Exhibit 7

Inter Parte Reexamination Communication Transmittal Form

REEXAMINATION CONTROL NO. : 95000578

PATENT NO. : 7619912

Figure 1A:

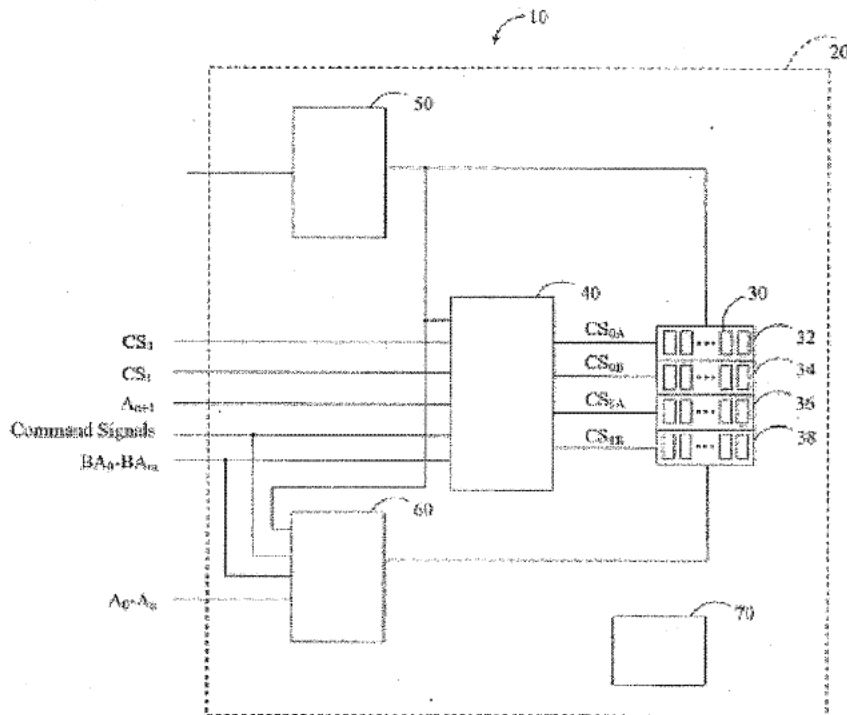
18. As shown in Figure 1 of the '912 patent, reproduced below, bank address signals "BA₀ - BA_m" are provided directly to an input of the logic element 40, which then utilizes the bank address signals to perform address translation functions and translate logical addresses, as viewed by the computer system, to actual physical memory addresses for activating a selected physical rank, and performing read/write operations onto the selected physical rank.

Annotated Memory Module illustrated in Figure 1A

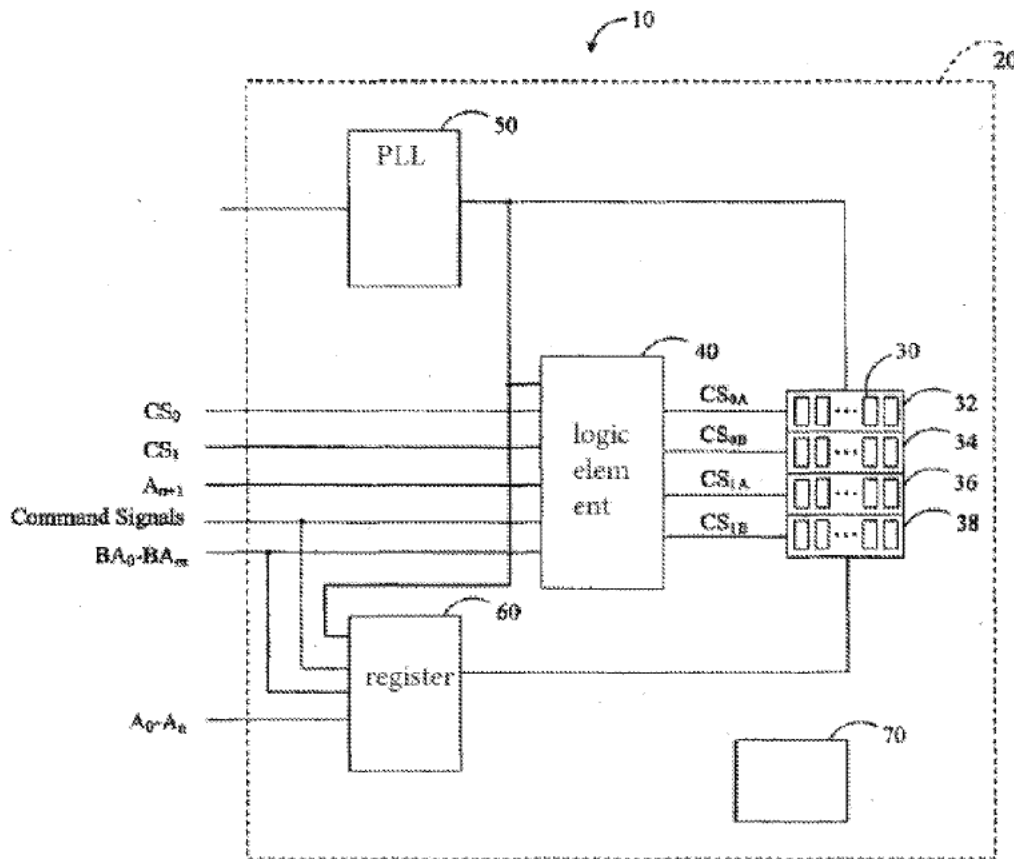
The '912 patent illustrates an exemplary memory module 10 in Figure 1A below:

Figure 2B showing Logic Element 40 with PLD 42 Storing Signals

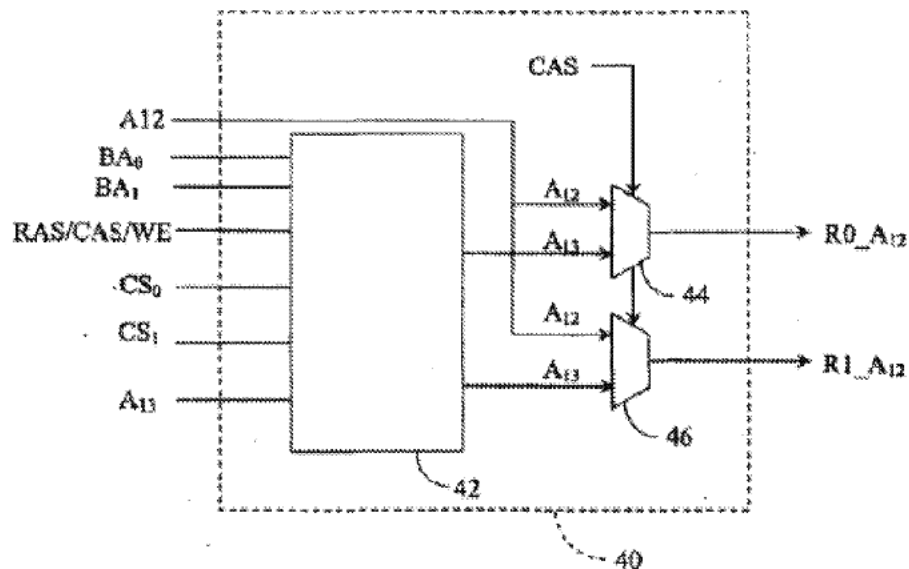
In addition, Figure 2B shows that logic element 40 can save or latch an input control signal (e.g., A_{13}) during a row access procedure (e.g., column access strobe (CAS) high) at program logic device (PLD) 42 and can transmit this signal as an output control signal during a subsequent column access procedure (e.g., CAS low). The '912 patent 21:54–66; Fig. 2A. Figure 2B illustrates this below:

The '912 patent 3:44–45; Fig. 2B. In this exemplary logic element, ranks 32 and 34 (shown in Figure 2A) interpret the previously-saved row address (e.g., A_{13}) as a current column address (e.g., A_{12}), and logic element 40 translates the extra row address into an extra column address. The '912 patent 21:66–22:4; Fig. 2A–B.
